Manufacturability Report Bandwidth Board

Analog Technologies Corp.

ATC has been providing incoming inspection feedback on several quick-turn boards provided by XXX. This report will summarize the findings for printed circuit board number 11TC0548 PCB (ATC 36387). This bandwidth circuit board is approximately 5"X8" with a single flip chip mounting location centered approximately 1/3 from then end of the board. The board is gold plated with exception of the flip chip area which is selective OSP coated. This board displayed several issues in the flip chip area that could have been deemed rejectable. In order to meet production demands, these boards were processed. The underlying issues need to be addressed at the design and/or fabrication level. The trace width and spacing requirements would make this board understandably difficult to fabricate.

Under-etched area that was manually modified resulting in compromised traces

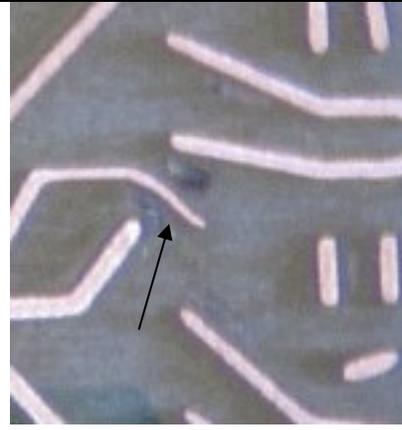
Trace etching – Trace etching was an issue in the case of both under- and over-etching. Under-etched areas appear to have been manually cut, leaving inconsistent trace widths and damaged solder ball lands. Over-etched areas resulted in ultra thin land areas for attachment.

Please feed this back to the PCB fabricator. With tight process control and best practices, board houses are consistently achieving these lines and spaces. The board vendor may have to look at their internal process to see what adjustments they can make. They may have some ideas for design practices that working in conjunction with their processes can minimize these types of anomalies. For example, based on the above photographs, one might suggest that if there is a constant mask boarder without nearby via features that affect the mask geometry, the plating chemistry intrusion can be reduced significantly.

Further evidence

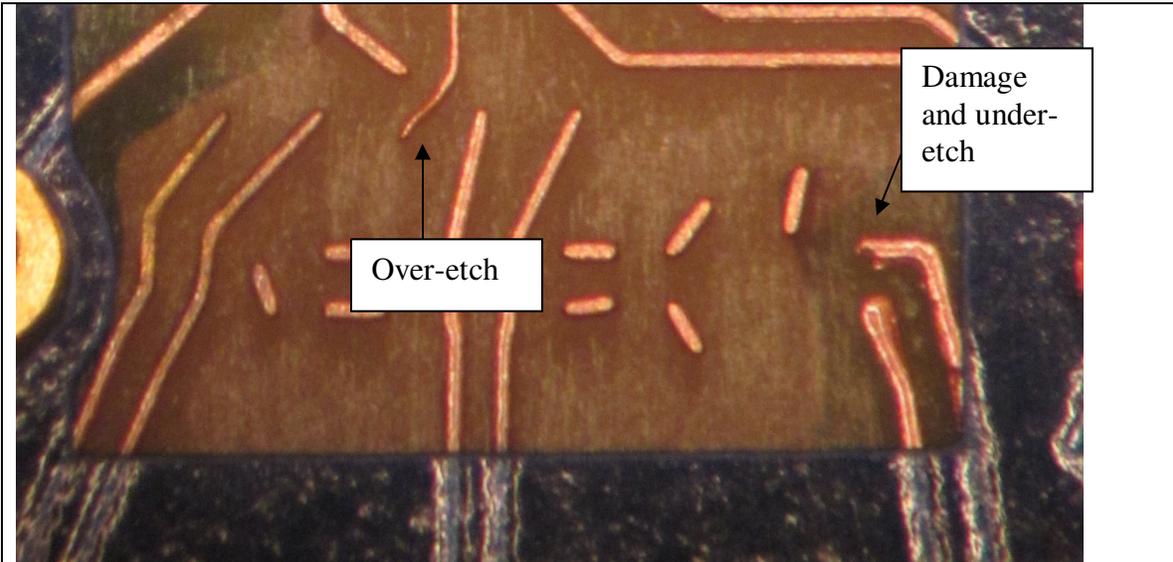
Many of the traces on in the flip chip area are over etched. This ultimately affects the collapse of the chip during processing and reliability.

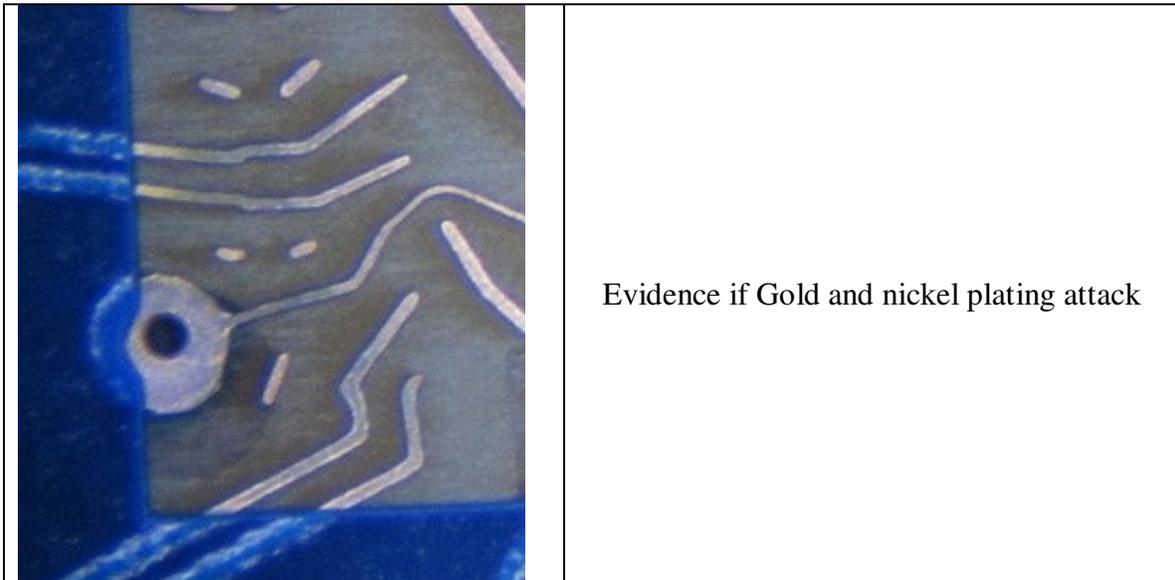
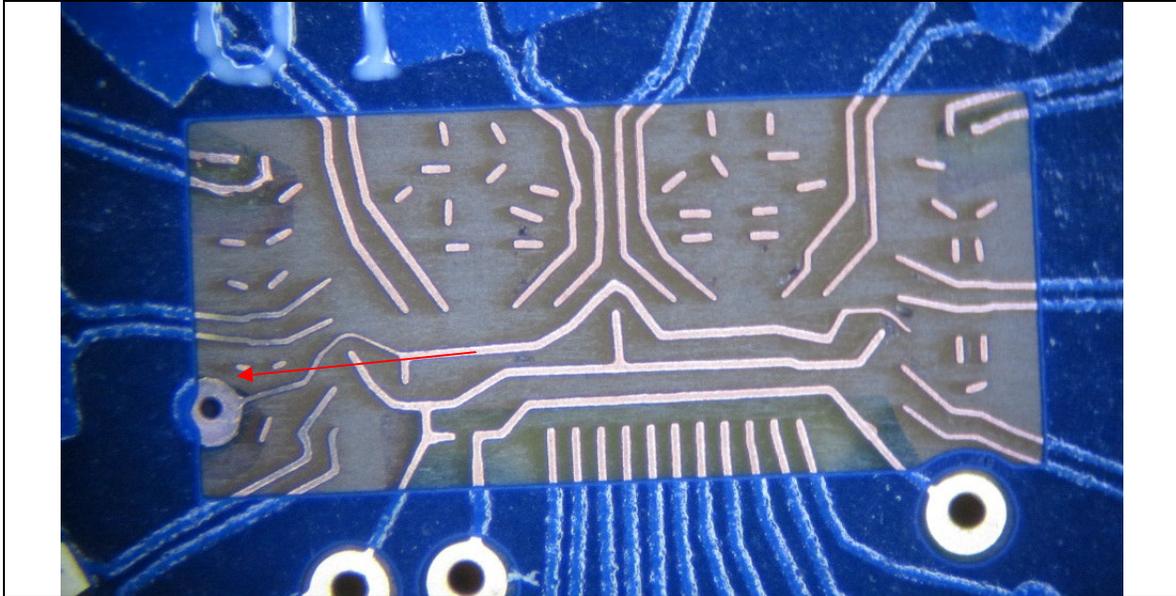
Plating – The gold plating process appears to have undesirable side affects could impact flip chip attachment. There appears to be some attack on the flip chip copper that is occurring during nickel or gold plating. Several traces appear to be discolored in the flip chip area. There are typically two sources for discoloration in the flip chip area. If the OSP coating is too thin or has degraded, the copper traces can oxidize. Secondly, if the plating chemistry reacts with the copper during gold and nickel plating processes, the attachment lands for the flip chip can be affected. This is especially true if the surface of the copper is compromised in such a way that the solder spheres cannot properly wet or form intermetallics with the surface.
